ADDENDUM No. 1
Request for Competitive Sealed Proposals (CSP)
20CSP040 Upgrades at Travis Heights Elementary School

December 5, 2019

195012 | Travis Heights Elementary

200025-TRVHT - IMPROVEMENTS TO TRAVIS HEIGHTS ELEM. SCHOOL
2010 Alameda Dr
AUSTIN, TX 78745

1 FIRST FLOOR ELECTRICAL
E2.02 1/16"=1'-0"

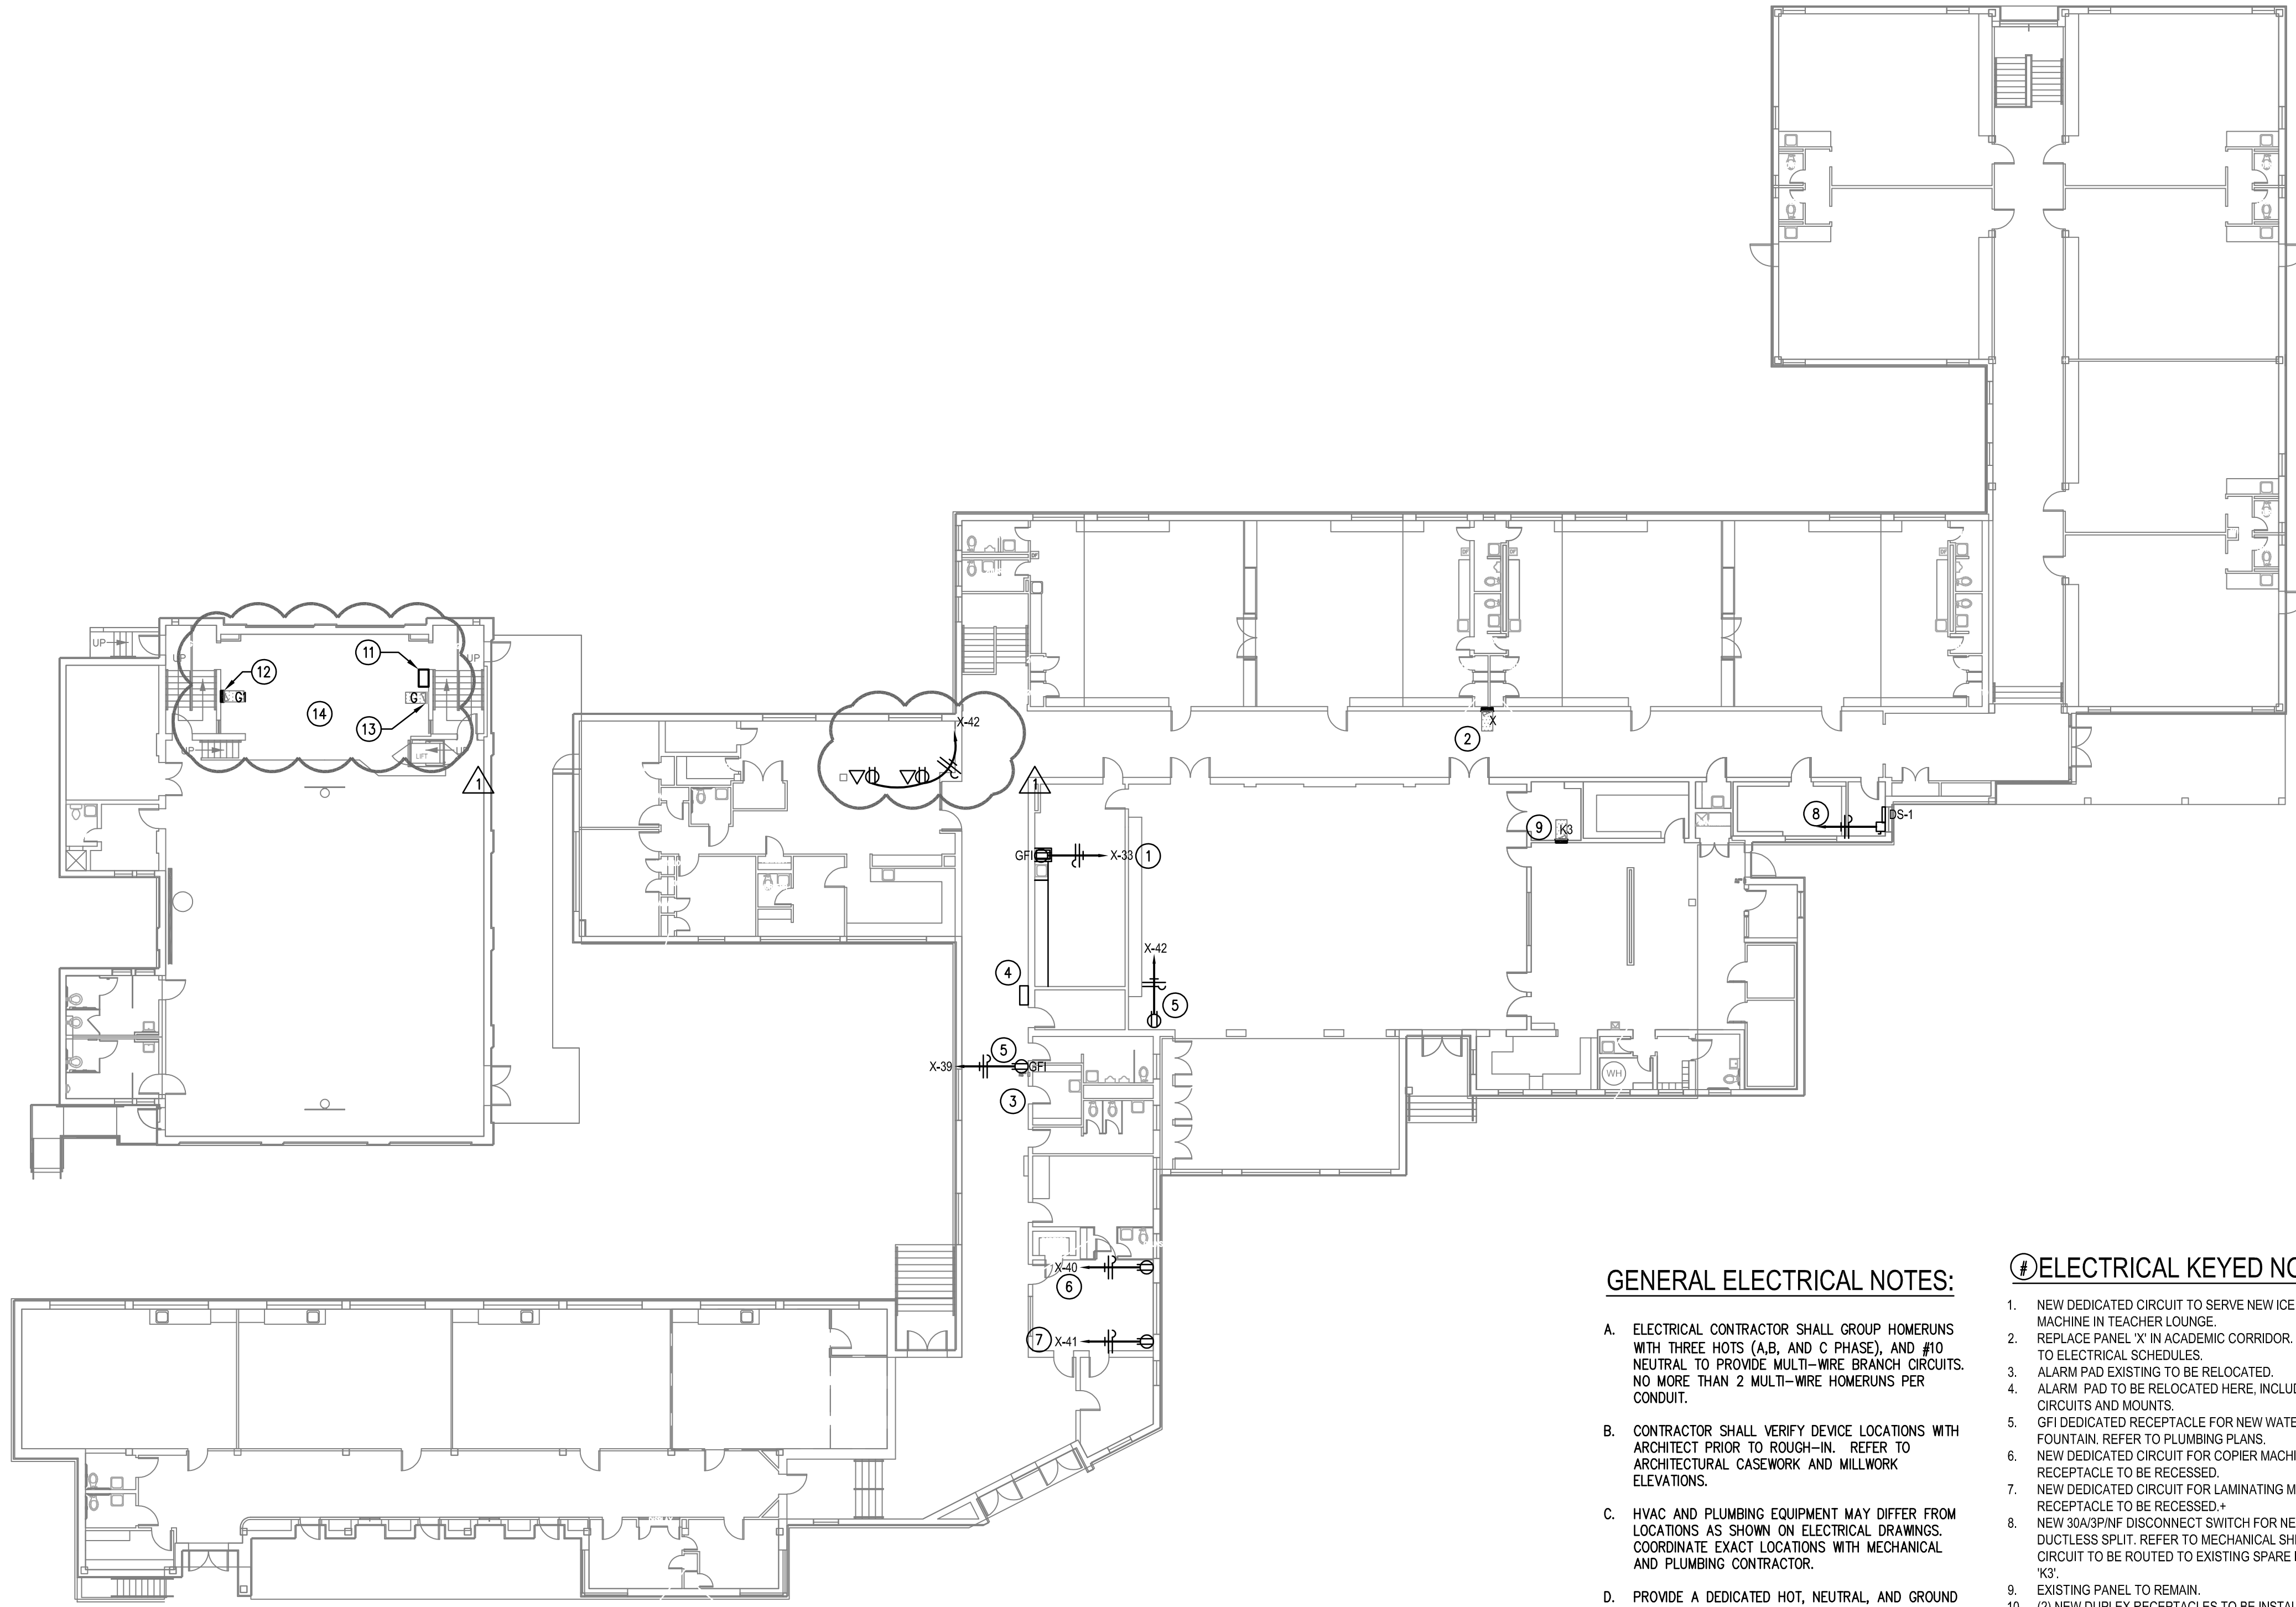
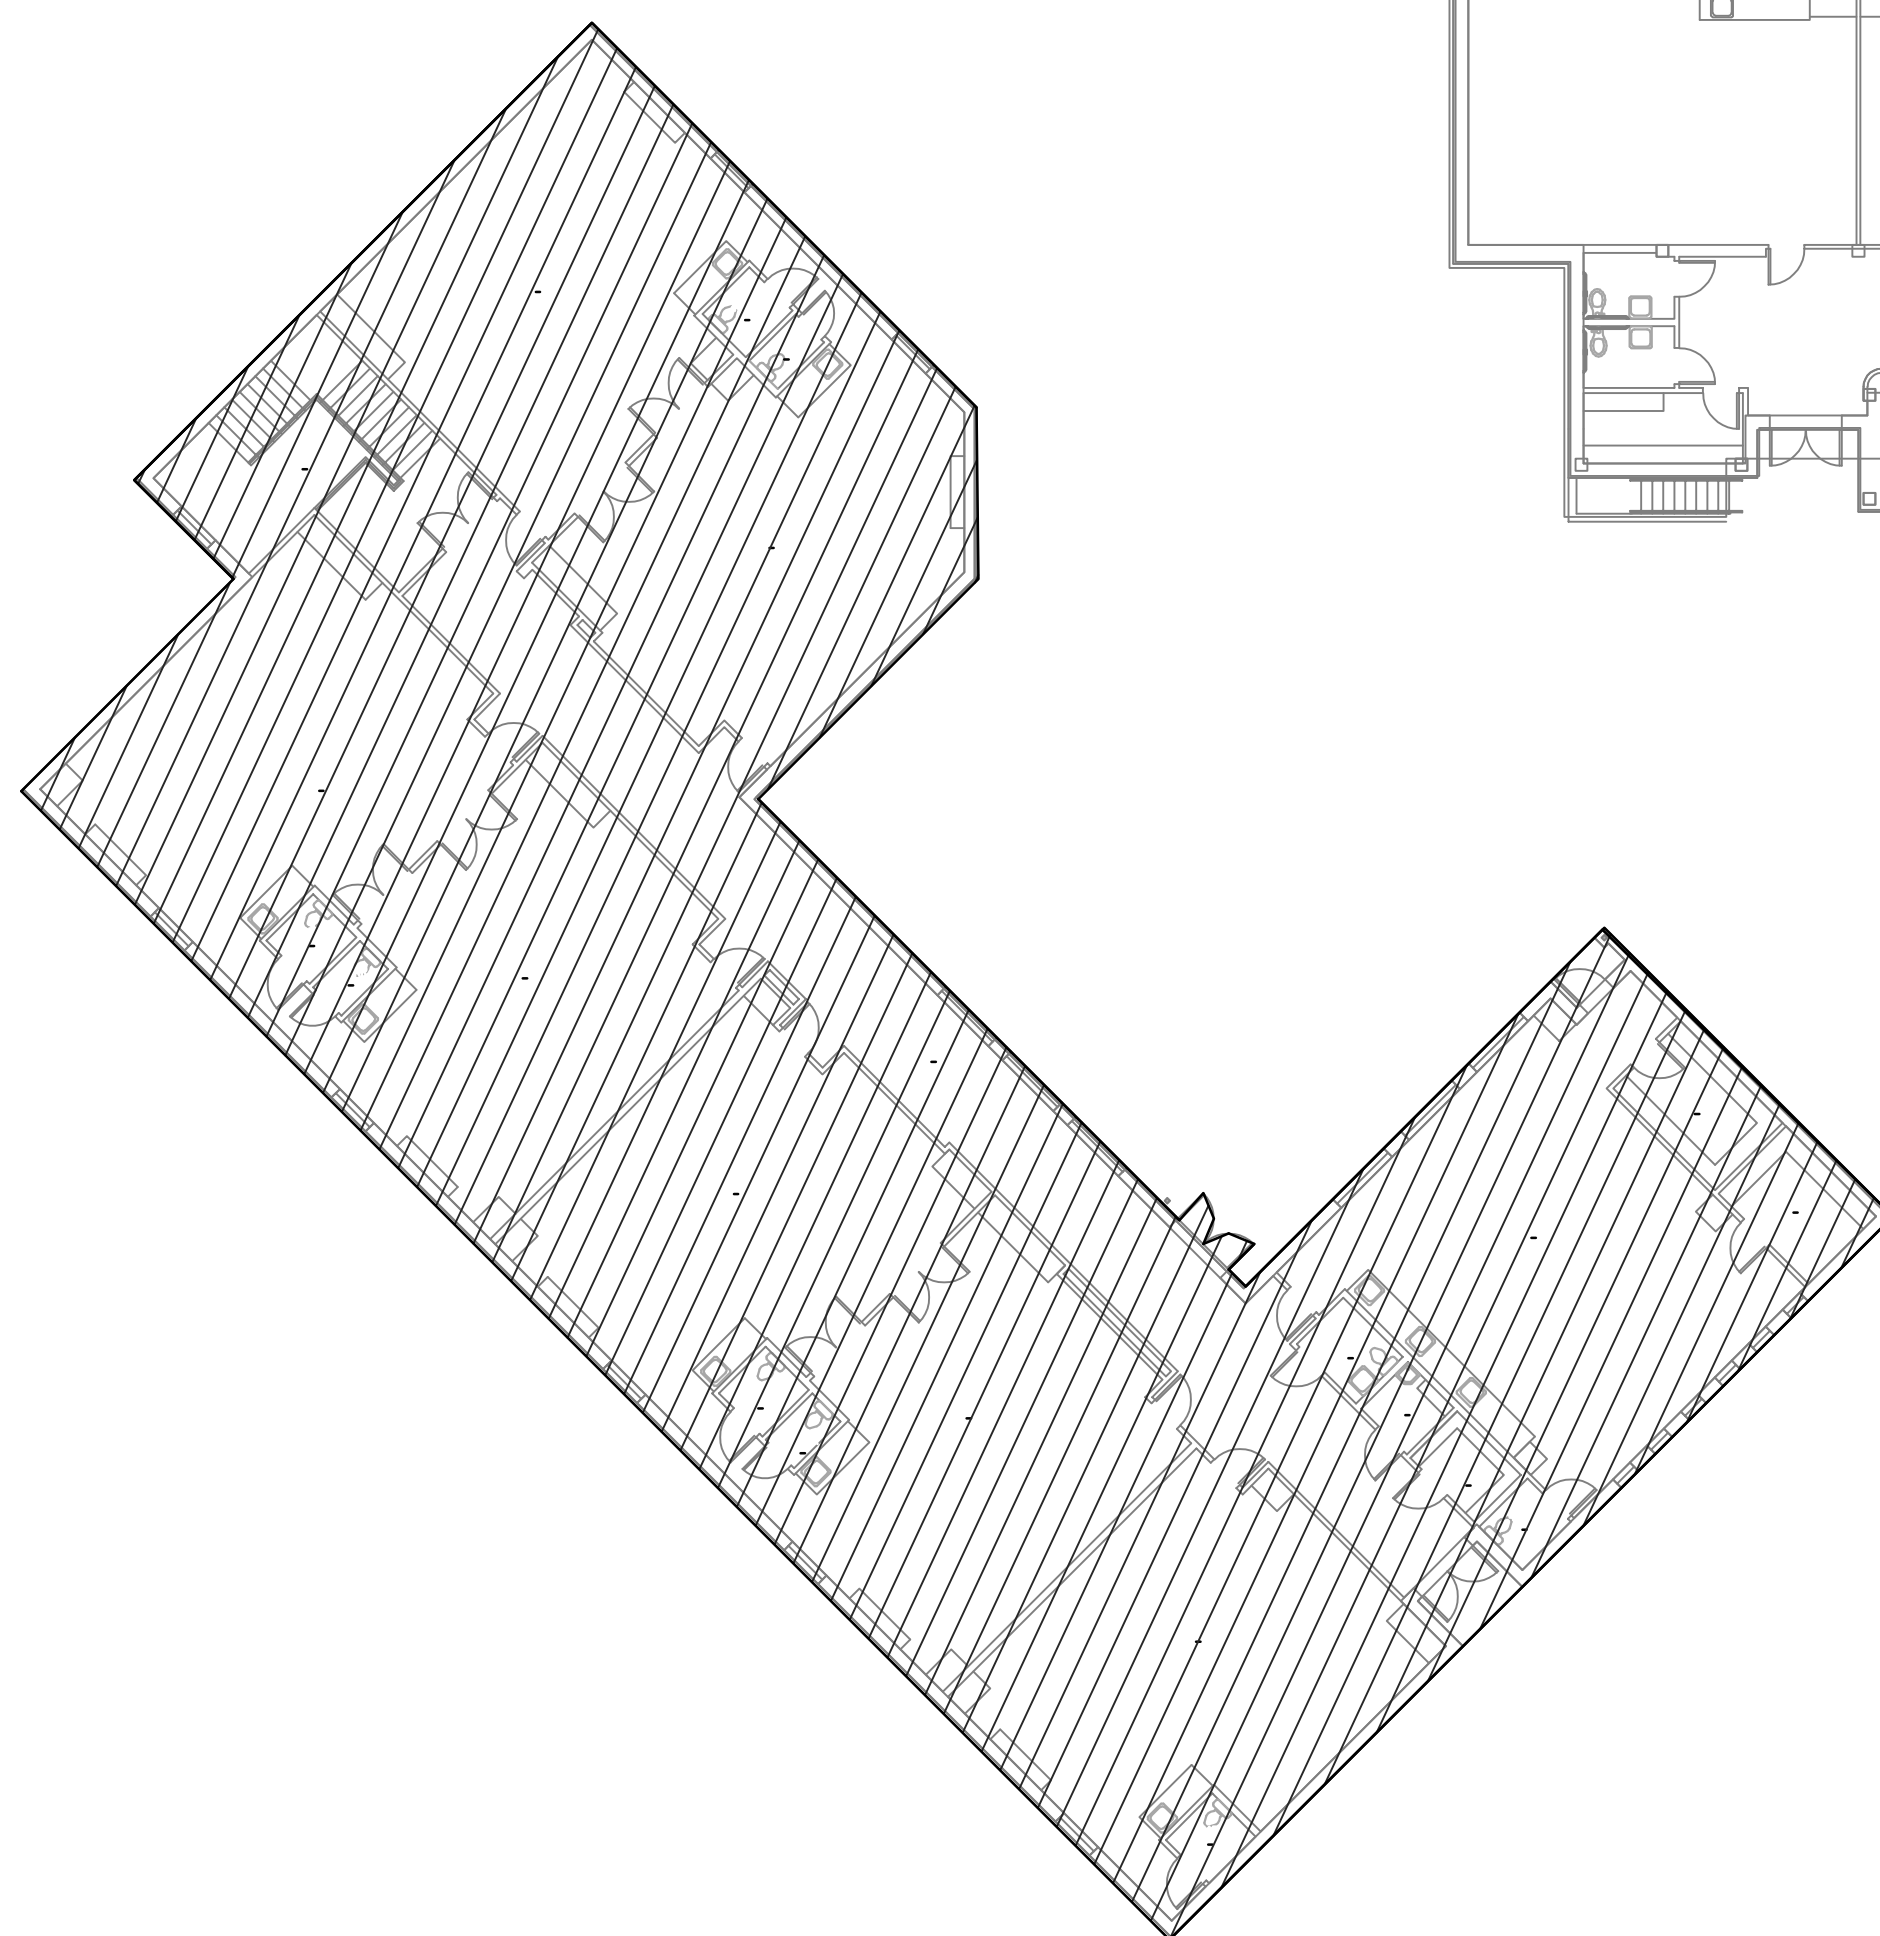
Item 03 **Sheet E2.02 – FIRST FLOOR ELECTRICAL PLAN**

- A. Power and data added to admin office desk.
- B. Remove existing stage lighting dimmer, replace with new panel, conventional incandescent dimmer, as indicate on plan

- 9. EXISTING PANEL TO REMAIN.
- 10. (2) NEW DUPLEX RECEPTACLES TO BE INSTALLED UNDER ADMIN DESK. REFER TO SHEET A2.03 FOR MOUNTING DETAILS.
- 11. REMOVE EXISTING DIMMER SWITCHES CONDUIT ASSOCIATED WITH DIMMING RACK. PROVIDE NEW LUTRON DIVA LINE VOLTAGE 1000W SWITCHES, 11 IN TOTAL, RECONNECTED TO STAGE LIGHTING CIRCUITS. EXISTING DIMMER RACK SHALL BE REPLACED WITH NEW PANEL. REUSE EXISTING INCOMING FEEDER TO SERVE NEW PANEL. RECONNECT EXISTING LIGHTING CIRCUITS TO NEW PANEL, WITH CIRCUITRY MODIFIED TO PASS THROUGH NEW DIMMER SWITCH INSTALLATION ACROSS STAGE.

- 12. EXISTING PANEL 5 WITH 100A/2POLE/1PH/PHASE 240V CONNECTION TO DIMMER RACK SHALL BE REUSED TO FEED NEW PANEL G1. G1 SHALL BE PROVIDED AS INDICATED ON PANEL SHEET E5.01.

- 13. LIGHTING RE-CIRCUIT SCOPE ON STAGE INCLUDES RE-CIRCUITING 11 EXISTING LIGHTING CIRCUITS, WITH FIXTURES TO REMAIN IN ORIGINAL LOCATION THROUGH NEW PANEL G1 WITH 11 NEW DIMMER SWITCHES (1 PER CIRCUIT). SURFACE MOUNT CONDUIT, BOXES, STRAPPING SHALL BE PAINTED TO MATCH EXISTING WALLS.
